**GLADSTONE PLANNING COMMISSION REGULAR AGENDA
GLADSTONE CIVIC CENTER, 18505 PORTLAND AVENUE
Tuesday, October 17, 2023 – 6:30 p.m.**

2. Monthly Planning Report – September & October 2023
3. **PUBLIC HEARING:** DR-23-06. Construction of a new 7,458 sq. ft. warehouse storage building. No proposed off-street parking or exterior storage. 6075 Duniway Avenue, Greg Philo.

The planning staff recommend approval of the Design Review application DR-23-06 and recommend the following findings and standard conditions in support of approval, as well as 4 special conditions: (1) Revised Building Elevations, Site Plan and Narrative; (2) Construction Plans for Public Improvements; (3) Right-of-Way Dedication and (4) Easements.

AS-001
 SHEET 15 OF 48

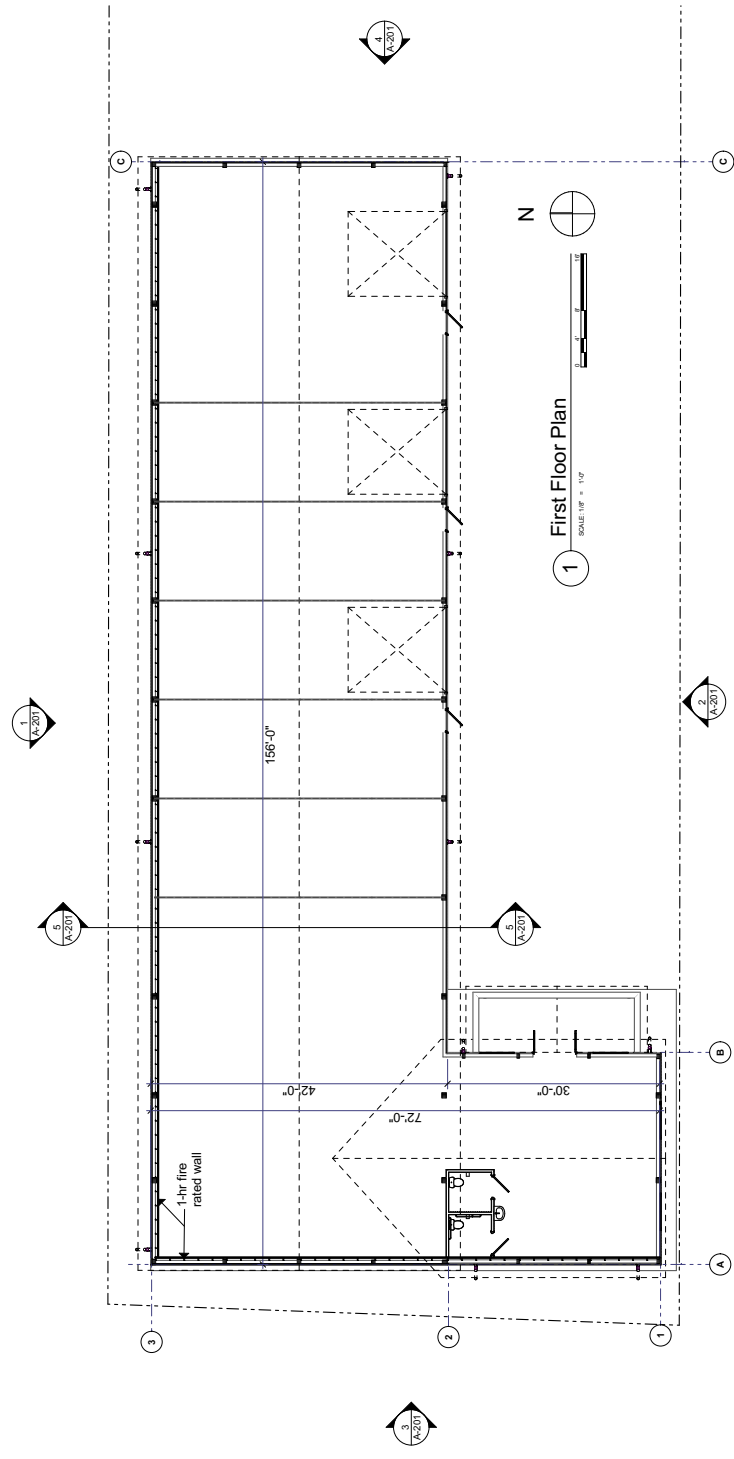
Finding: The proposed improvement area "project area" is approximately 22,215 square feet (0.51 ac). Sheet AS-001 identifies 3,935 square feet of landscape area which is 17.7%, exceeding the minimum 15% required. However, Sheet C2.00 identifies 2,420 square feet of landscape area in different locations on the site from AS-001, not meeting the requirements of this section. It is unclear exactly where the landscaping will be provided to meet this requirement. This standard can be met as conditioned below.

Condition: Prior to building permit approval, submit a revised site plan to the Gladstone Planning Department that demonstrates a minimum of 3,333 square feet of landscaping on this 22,215 square foot site, in accordance with GMC 17.46.020(1).

1 North Elevation
SCALE 1/8" = 1'-0"

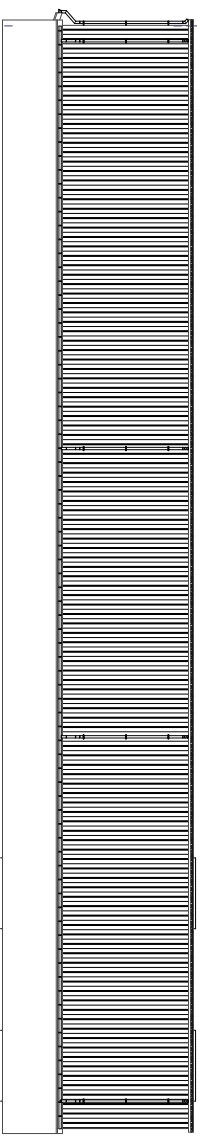
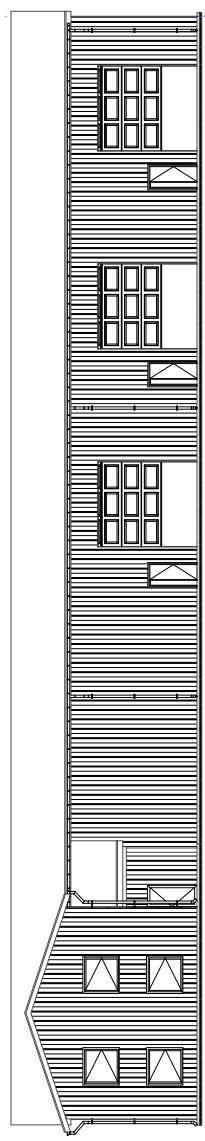
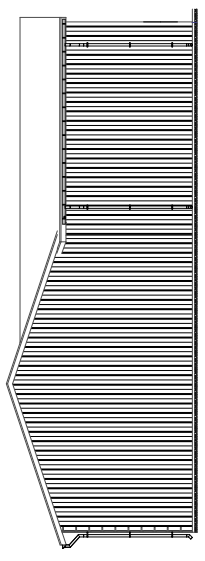
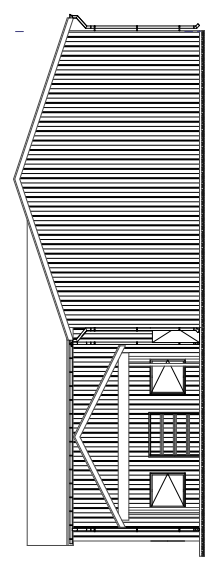
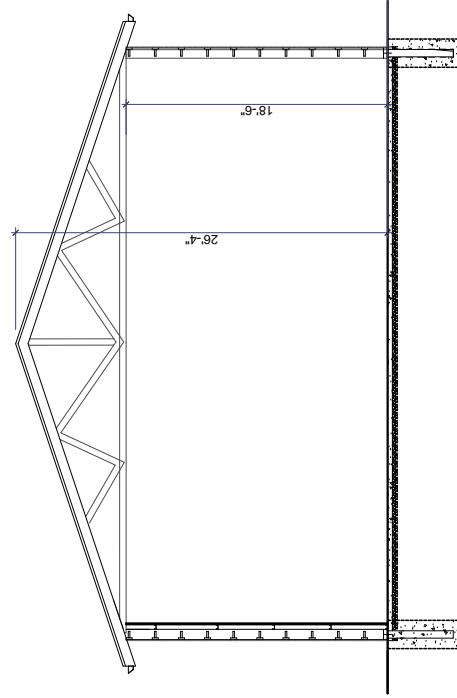
Finding: The submitted narrative states, "The use of metal materials has to be explicitly approved by the Planning Commission". It is unclear from the narrative or the submitted plans if metal is proposed. Given the lack of information on the exterior materials proposed, this standard can be met as

Condition: Prior to building permit approval, submit revised building elevations to the Gladstone Planning Department that demonstrates all exterior materials and finishes are high-image such as masonry, architecturally treated tilt-up concrete, glass, wood or stucco and no metal siding is utilized unless specifically approved by the Planning Commission, acting as the design review committee, in accordance with GMC 17.44.020(4).

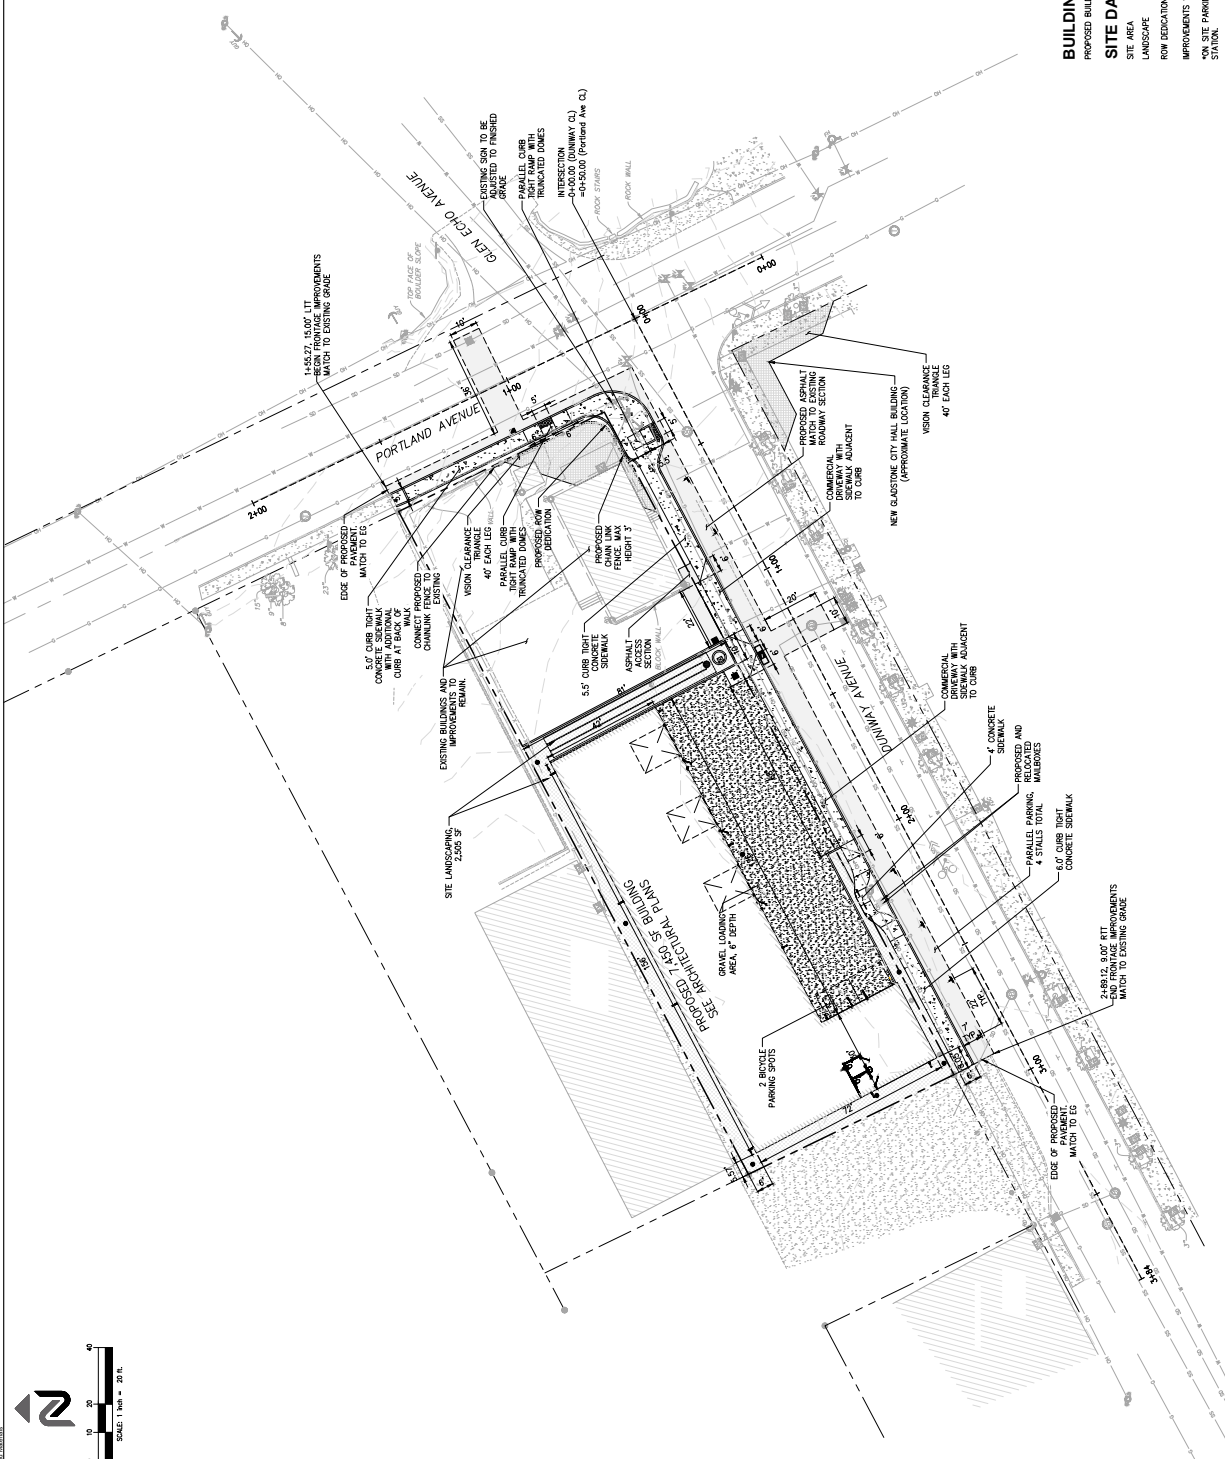
Finding: It is unclear from the submitted plans if the loading area will be paved with concrete or asphalt. Gravel is noted for the loading bays; however, there is no indication that this meets the provisions of this section. Drainage is indicated on Sheet C3.00 and does not flow across the public sidewalk. There are no residential properties abutting the proposed loading area.

Condition: Prior to building permit approval, submit a revised site plan to the Gladstone Planning Department that demonstrates that the loading area is constructed of asphalt or concrete and meets the provisions of GMC 17.48.040(1).

**GRADING AND
DRAINAGE PLAN**

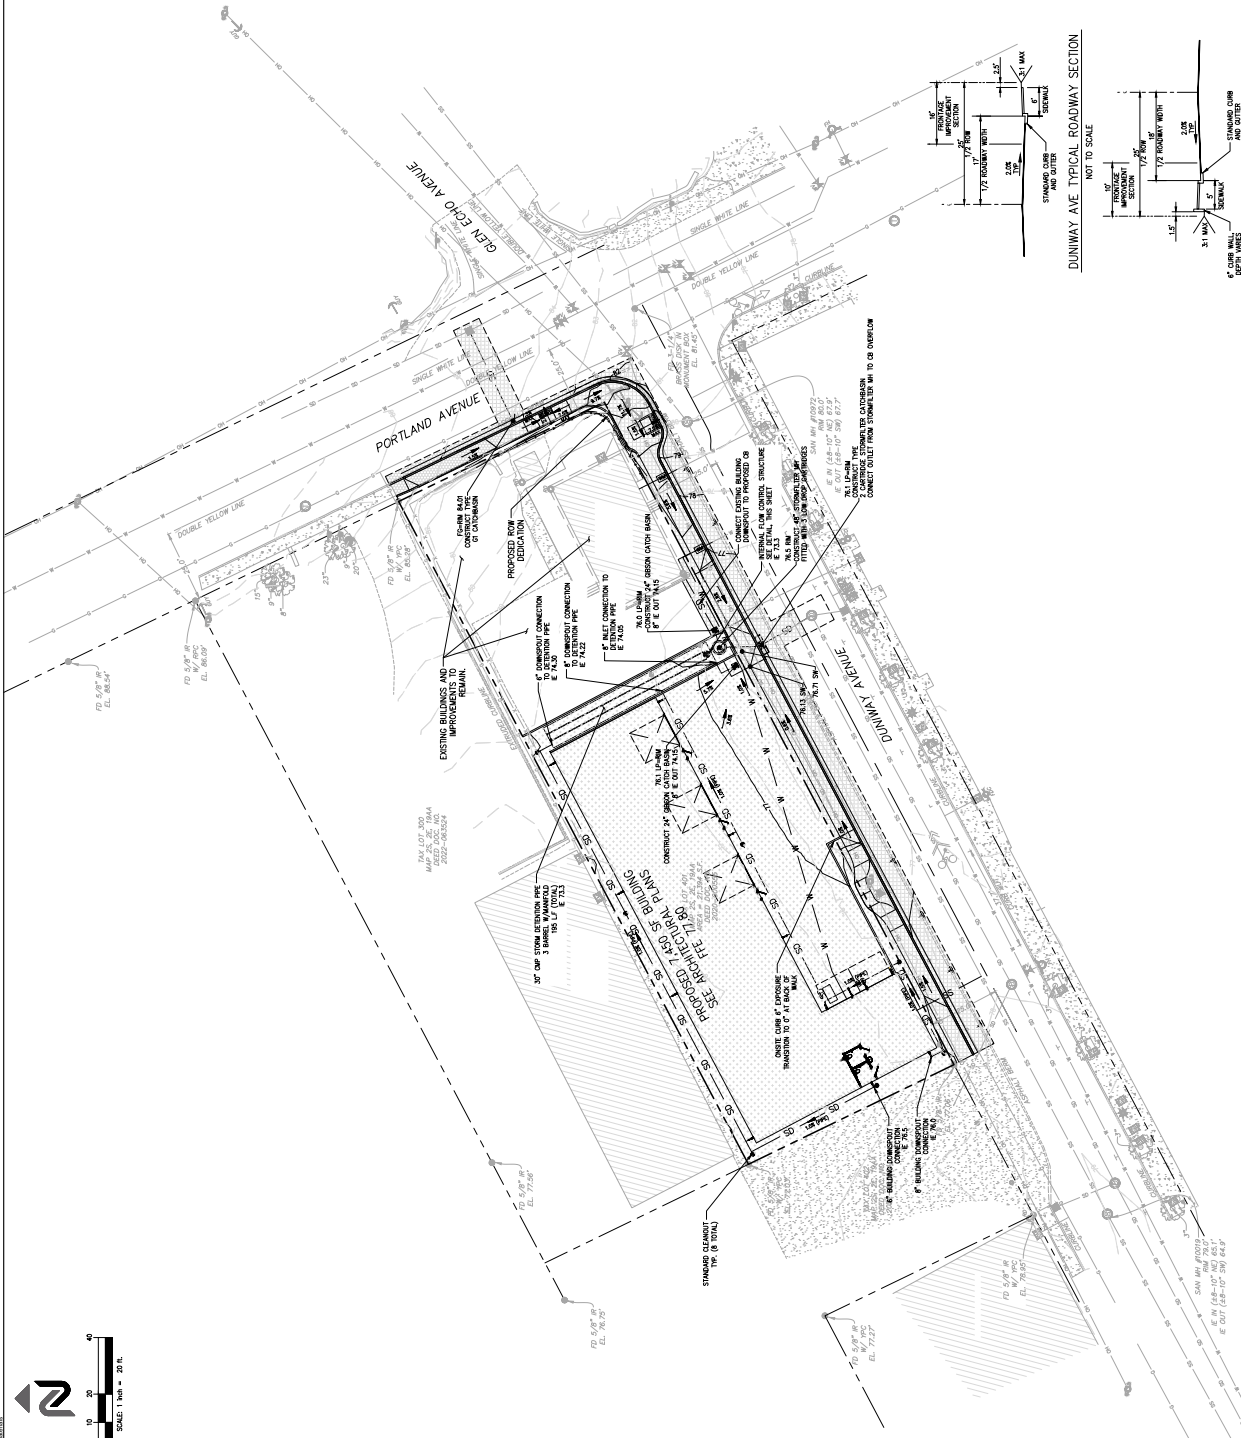
Finding: No details provided regarding landscaping irrigation or maintenance, overall plant species or street trees is provided. Sheet C3.00 identifies grading preserving the natural form of the site without berming or contouring of the land. There is no land within the public right-of-way that will not be developed. This site is not along McLoughlin Blvd. The proposed addition to the site exceeds 5,000 square feet and must therefore meet the current minimum landscaping standards, regardless of existing development on the site. These standards can be met as conditioned below.

Condition: Prior to building permit approval, submit a revised site plan to the Gladstone Planning Department that demonstrates landscaping irrigation and maintenance, overall plant species and street tree details, all of which shall comply with GMC 17.46.020(3)-(5) and (8).
